UNITED STATES PATENT AND TRADEMARK OFFICE

APPLICATION NO.	FILING DATE	FIRST NAMED INVENTOR	ATTORNEY DOCKET NO.	CONFIRMATION NO.
10/624,848	07/21/2003	Craig Richard Gerbi	017516-006810US	6559

Office Action Summary	Application No. 10/624,848	Applicant(s) GERBI ET AL.	
	Examiner Natalie Pous	Art Unit 3731

DETAILED ACTION

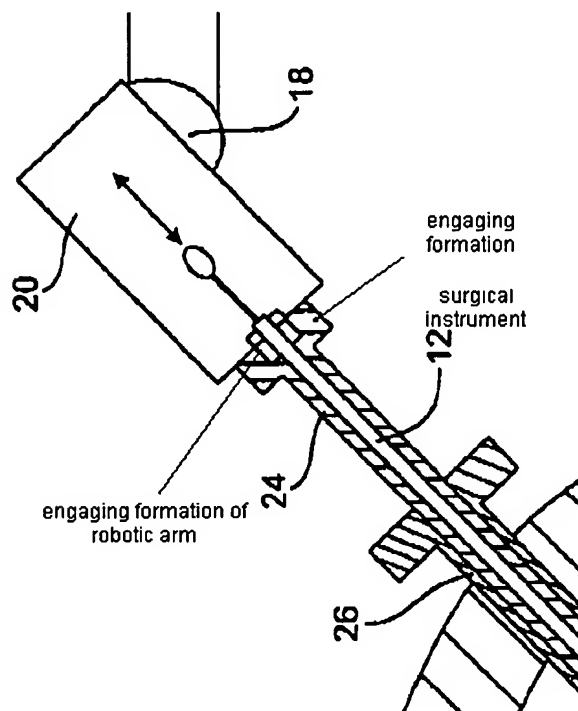
Regarding Claim 18, Wright teaches a tool guide comprising: an elongate body (24) defining opposed ends and a passage extending within the body between opposed ends (fig. 1); and an engaging formation defined within the passage of the body (see fig below), the engaging formation being arranged to hold and provide a stop for a complementary engaging formation on a robotic arm so that a passage defined within the complementary engaging formation is aligned with the passage of the elongate body

and a surgical instrument (12) passing through may be guided to a surgical site (14) in a patient body when the elongate body is inserted through an aperture of the patient body (fig. 1)

Regarding Claim 19, Wright teaches the tool guide of claim 18, wherein the engaging formation comprises a socket formation (24)

Regarding Claim 21, Wright teaches the tool guide of claim 19, which comprises an inlet which leads into passage (34), the inlet being arranged to be accessible from outside the patient body (fig. 1) when the tool guide is mounted in the aperture, the socket formation being positioned adjacent the inlet, and an outlet (44) which leads from the passage, the outlet being arranged to be positioned within the patient body (14) when the tool guide is mounted on the patient body (fig. 1).

Regarding Claim 22, Wright teaches the tool guide of claim 21, wherein the socket formation (24) comprises a circumferentially extending surface (42) defining at least part of the passage, the surface tapering radially inwardly in a direction away from the inlet (fig. 2).
